# Access Compliance Report

## Public Rights-of-Way

### (Curb Ramps)

Intersection ID: N/A	Main Street: STYLE_LN	Cross Street: OUTLETS_BV	Location: SW
ADA ID: 7C7DB96DD3EB	Ramp Type: PerpDiag	Initial Pass/Fail: Fail	Overall Compliance: No
		Severity Score: 8.75

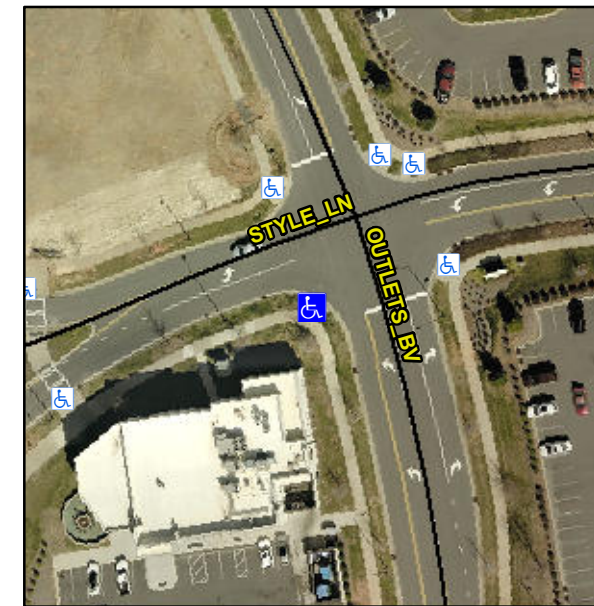
**R304.5.1**

Compliance	Description	Data	Compliance	Description	Data
N/A	Ramp Length (in)	97.0	Yes	Ramp Slope (%)	7.6
No	Ramp Width (in)	45.0	Yes	Ramp XSlope (%)	1.9
N/A	Flare Type LT	N/A	N/A	Flare Type RT	N/A
N/A	Flare Slope LT (%)	N/A	N/A	Flare Slope RT (%)	N/A
N/A	Flare Traversable LT?	N/A	N/A	Flare Traversable RT?	N/A
N/A	Landing Length (in)	N/A	N/A	DWS Provided?	N/A
N/A	Landing Width (in)	N/A	N/A	DWS Contrast?	N/A
N/A	Landing Slope (%)	N/A	N/A	DWS Length (in)	N/A
N/A	Landing X Slope (%)	N/A	N/A	DWS Full Width?	N/A
N/A	Landing Curb? (Y/N)	N/A	N/A	DWS Offset (in)	N/A
N/A	Shared Landing?	N/A			
N/A	Gutter Ponding?	N/A	N/A	Gutter Slope (%)	N/A
N/A	Gutter Lip Ht (in)	N/A	N/A	Gutter X Slope (%)	N/A
N/A	Painted X Walk1?	No	N/A	Painted X Walk2?	No
	X Walk 1 Direction	To E		X Walk 2 Direction	To N
N/A	X Walk 1 Width (in)	N/A	N/A	X Walk 2 Width (in)	N/A
	X Walk 1 Slope (%)	4.7		X Walk 2 Slope (%)	2.6
	X Walk 1 X Slope (%)	2.7		X Walk 2 X Slope (%)	4.0

**Remove & Replace Curb Ramp With Two New Directional Ramps or Equivalent.**
